Public Input No. 1528, Assigned to Code-Making Panel 9, Refer to Code Making Panel 10 and 18

Public Input No. 1528-NFPA 70-2023 [Definitions (100): Switch, Gen... to Switch, Iso...]

Figure Informational Note Figure 406.22~~10~~(B) One Example of a Symbol Used to Identify the Termination Point for an Equipment Grounding Conductor.

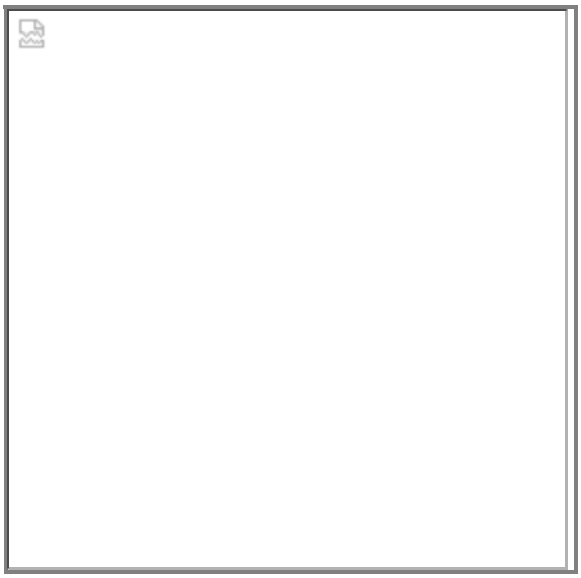
Commented [TBL39]: Reference to Figure 406.10(B) renumbered to Figure 406.22(B).

Commented [TBL40]: Figure 406.10(B) renumbered to Figure 406.22(B).

SCALE: 1 : 1	ALUMIWARE LABEL FOR ALUMINUM WIRING DEVICES PATENT PENDING
DATE: 12/4/18	Matthew Kirvan, 4515 Roxbury Dr., Bethesda, MD 20814, 301-512-8928

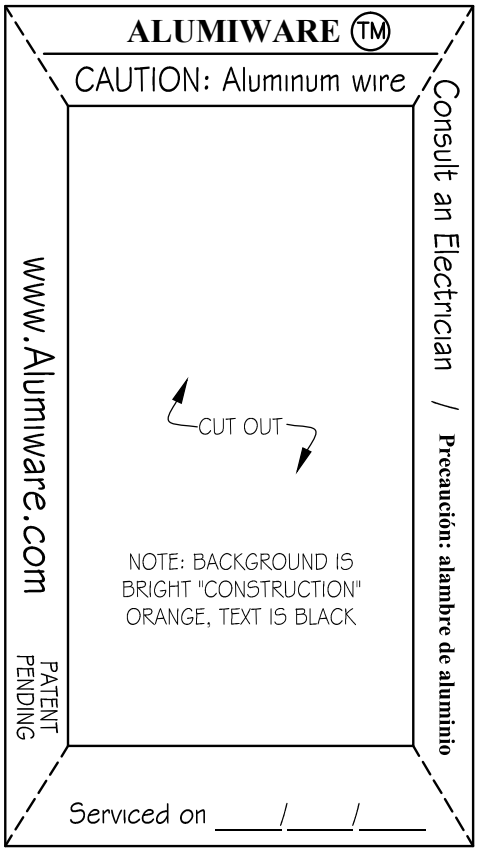
This input seeks to prevent mishandling of aluminum wiring conditions, when nonprofessionals seek to make repairs and/or receptacle changes without proper knowledge of aluminum wiring requirements. Many "do it yourself" homeowners, and amateur handymen will attempt to make repairs, when ignorant of aluminum wire conditions or hazards. This label will add an additional level of protection against incorrect material being used for repairs and modifications.

406.4(D)(2)(b)+(c) Revisions

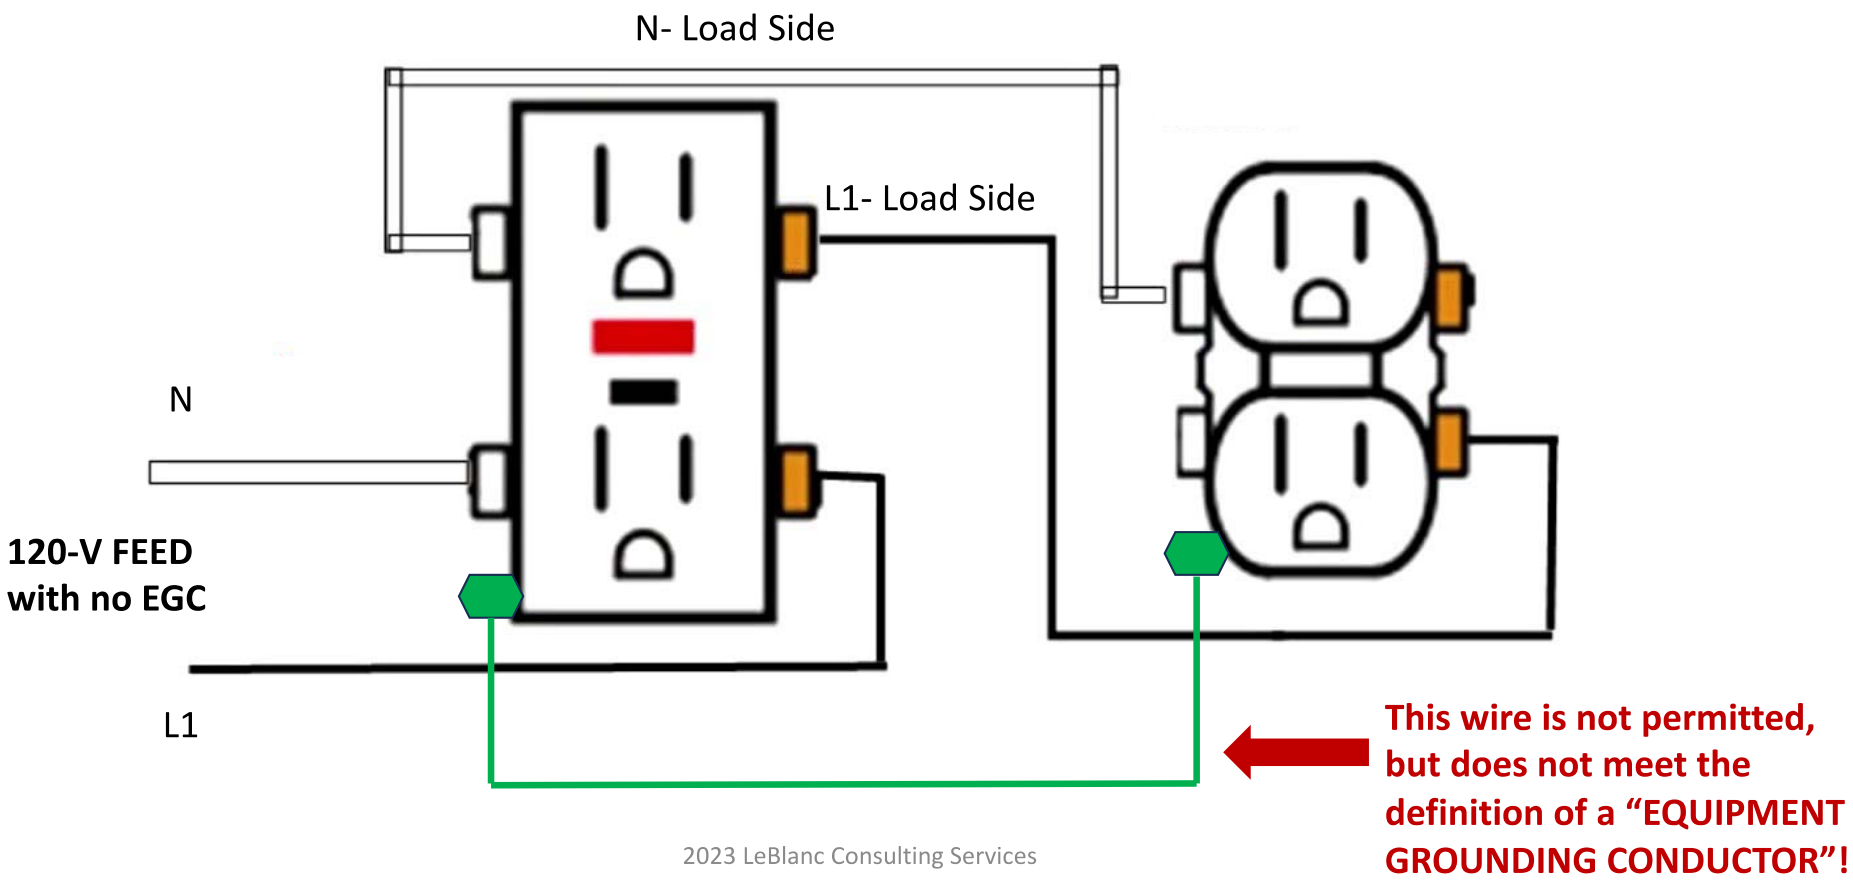
Application of the exception should not be limited to the size of a single box size only. Code language should be added that requires consideration of upstream outlet boxes to accommodate the installation of a GFCI receptacle to provide downstream protection. Another option for providing GFCI protection is the use of a GFCI circuit breaker. Both of these additional options should be required before allowing the use of the exception.

Exception: Where the outlet box size will not permit the installation of the GFCI receptacle and if no electrically upstream outlet box will permit the installation of a GFCI receptacle and if a GFCI circuit breaker cannot provide required GFCI protection , the receptacle shall be permitted to be replaced with a new receptacle of the existing type, where GFCI protection is provided and the receptacle is marked "GFCI Protected" and "No Equipment Ground," in accordance with 406.4(D)(2)(a), (D)(2)(b), or (D)(2)(c), as applicable.

Device box covers switch located on filler.

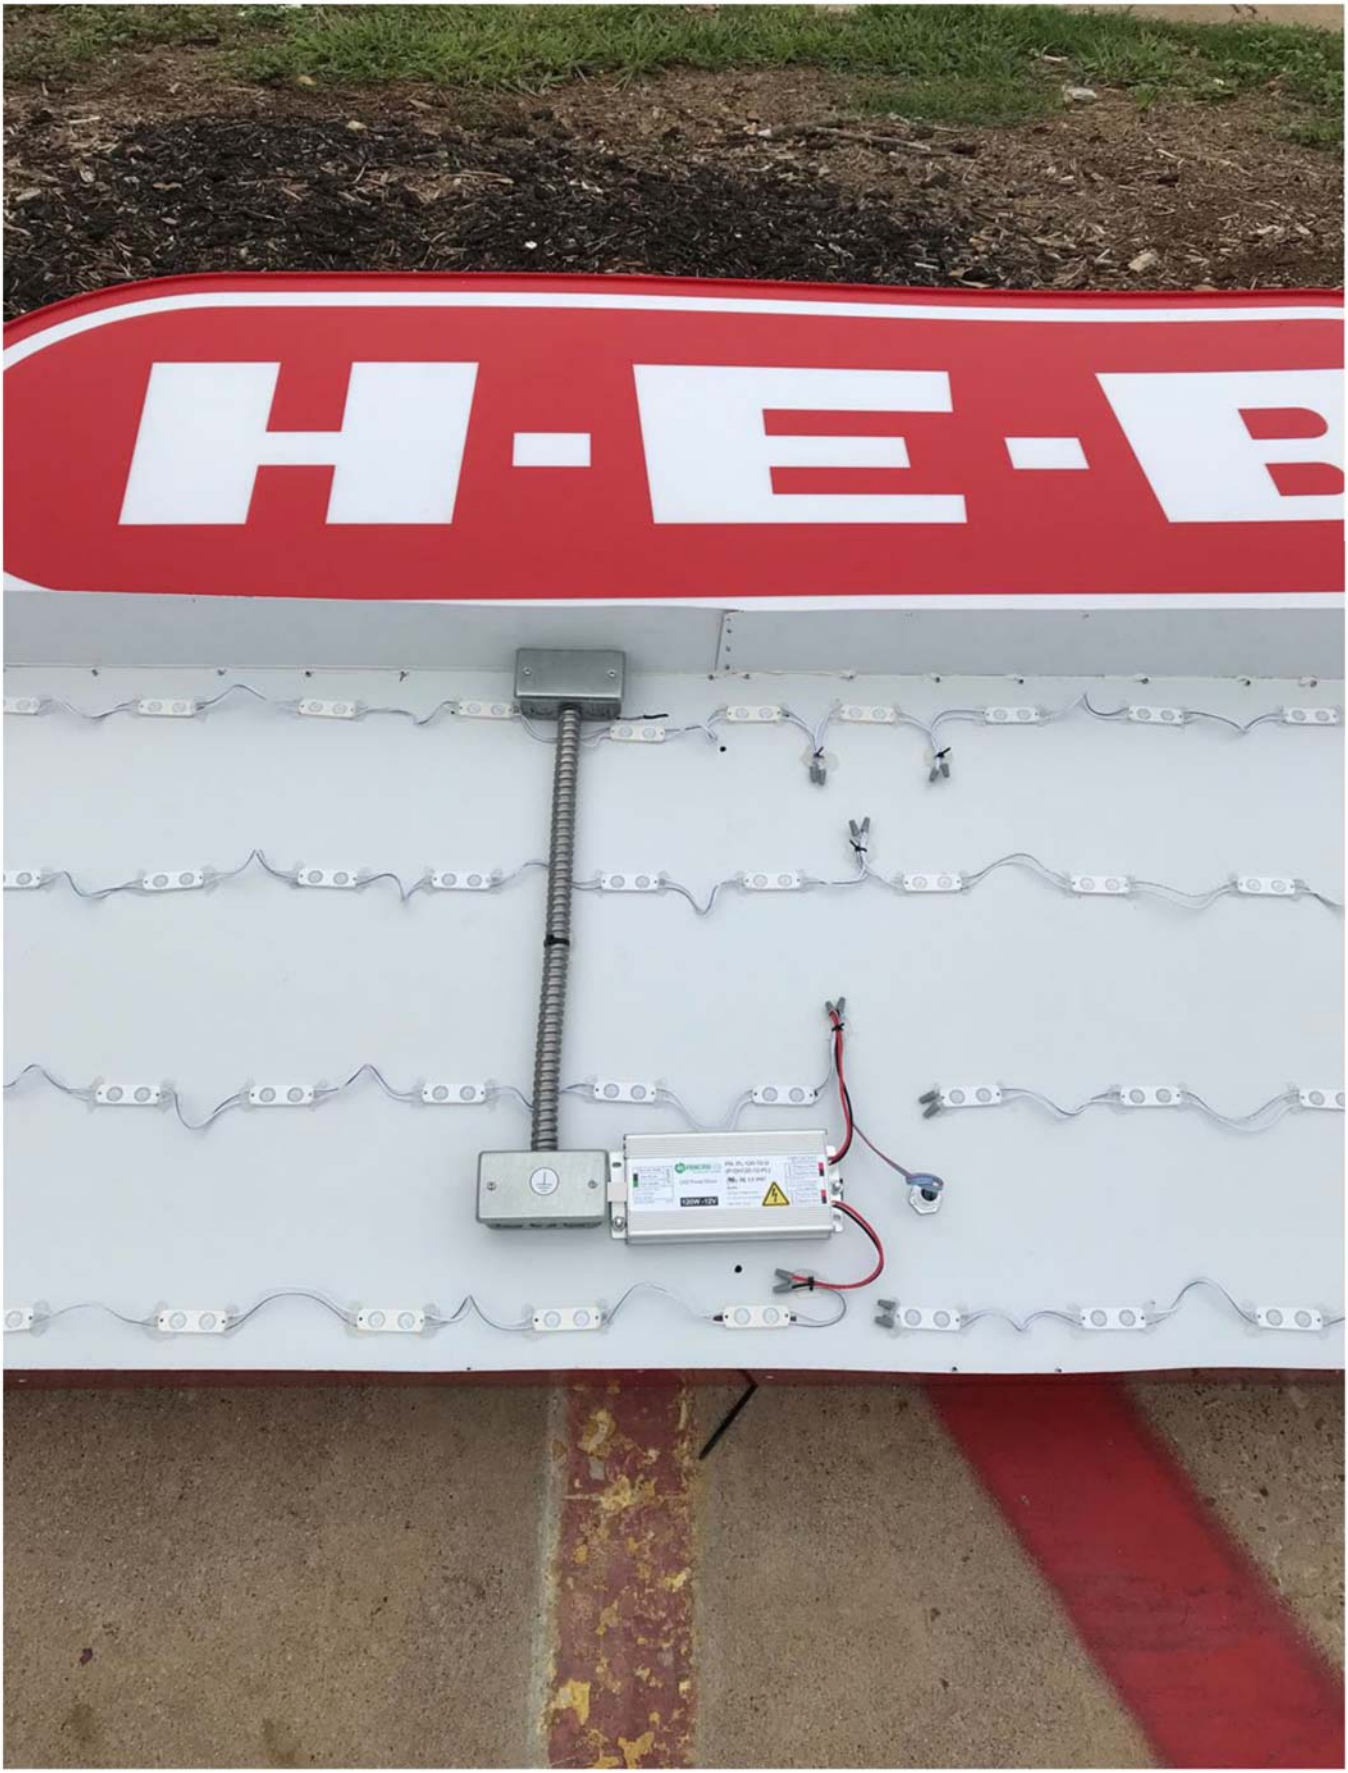
Chapter 3 wiring method will terminate into a device box.

Branch circuit conductors enter the top device box thru the sign body which is located over the switch, through the sign in a chapter 3 raceway to the termination with the Class 2 power supply conductors in the second device box.

Remote wired Class 2 channel letter metal bonded. 3 wire Class 2 cable installed.

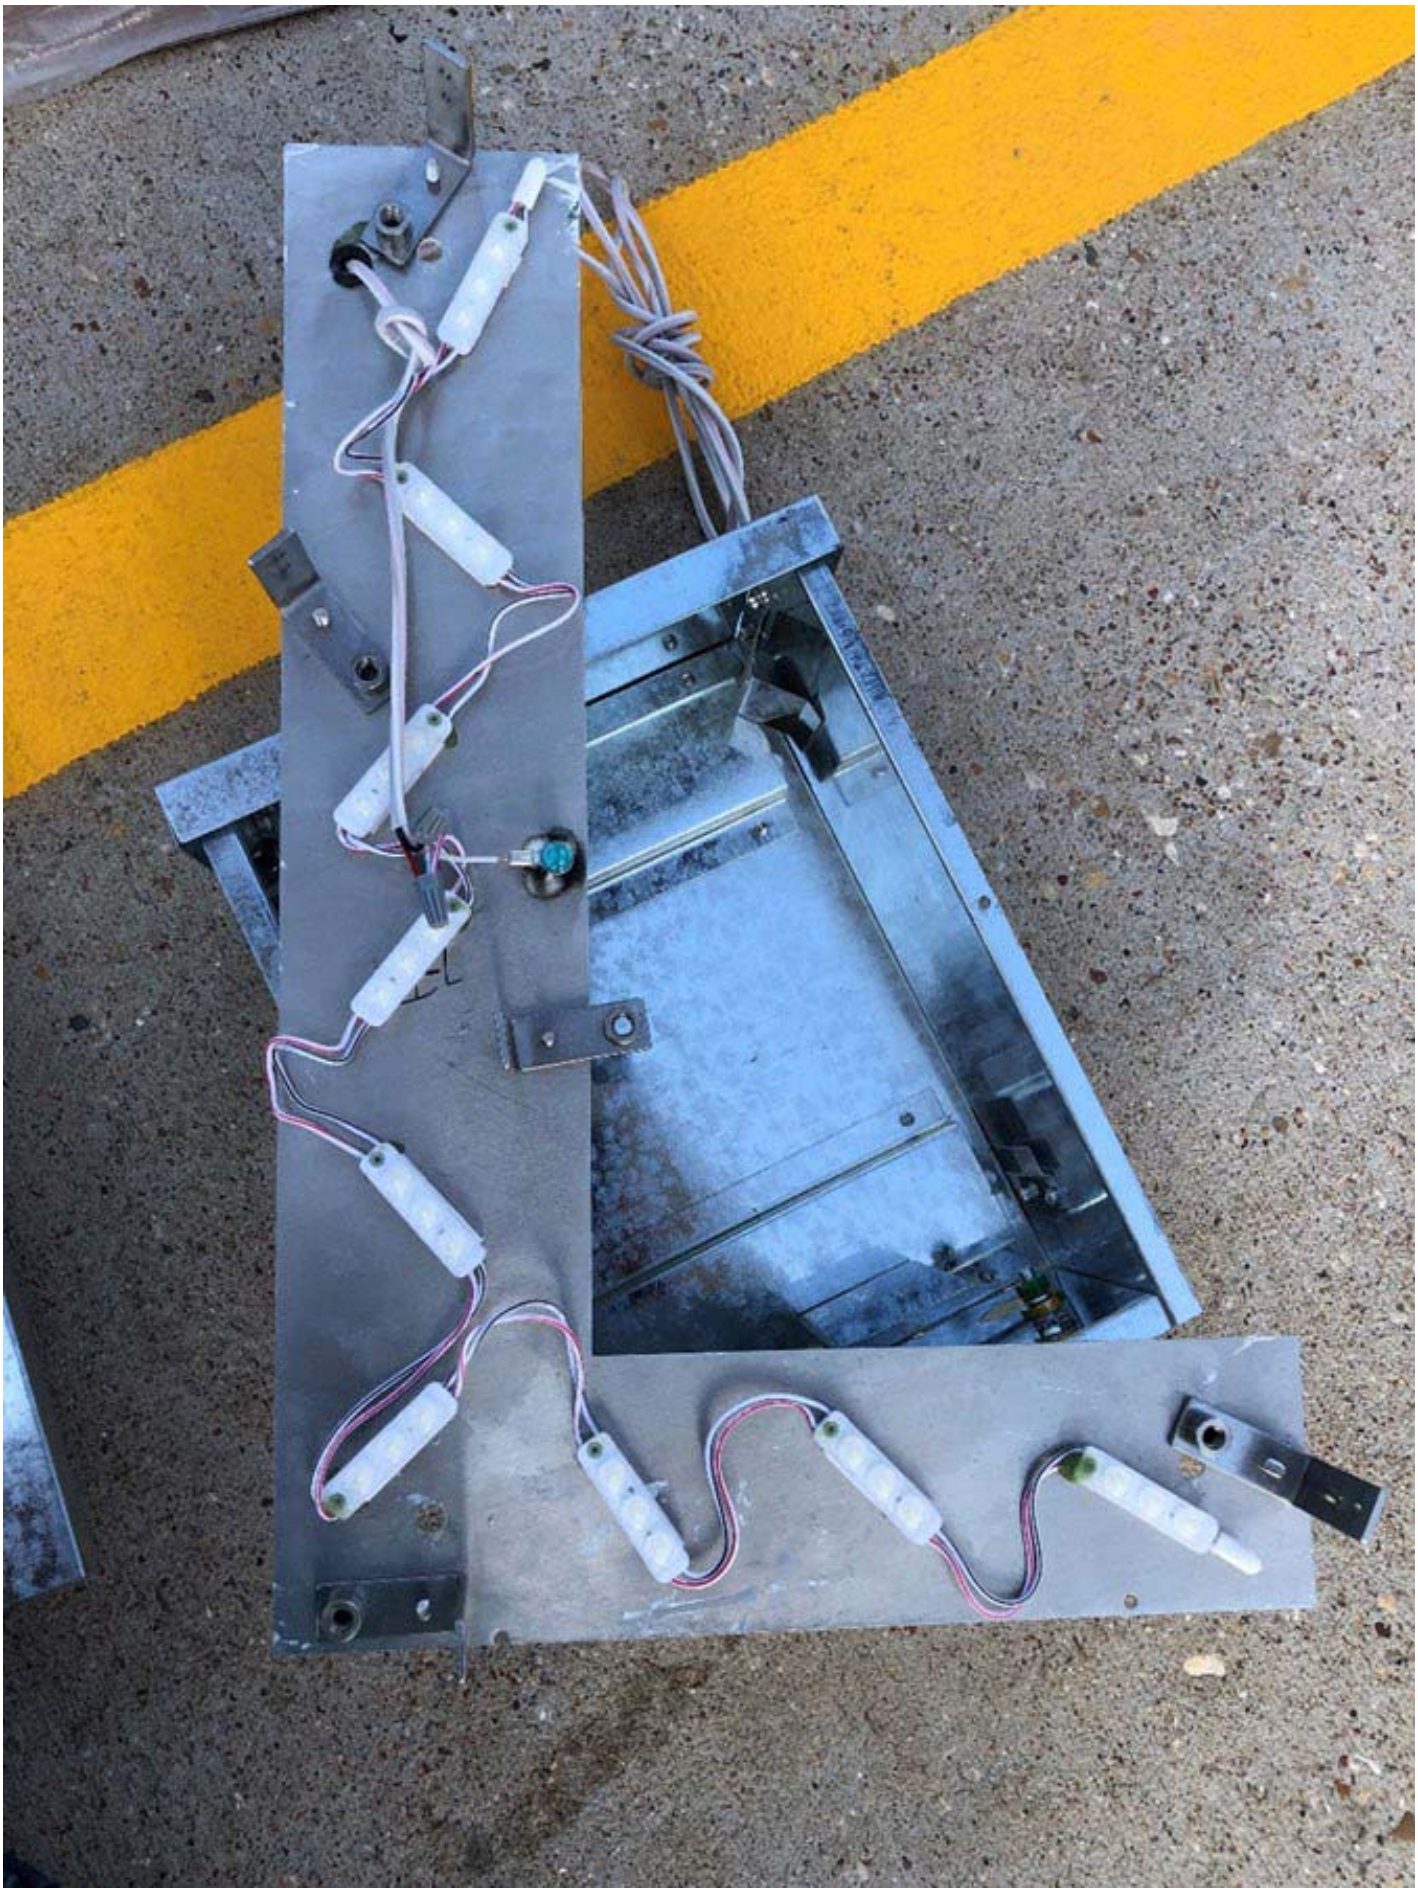
Remote wired Class 2 channel letter metal not bonded. 2 wire Class 2 cable installed.
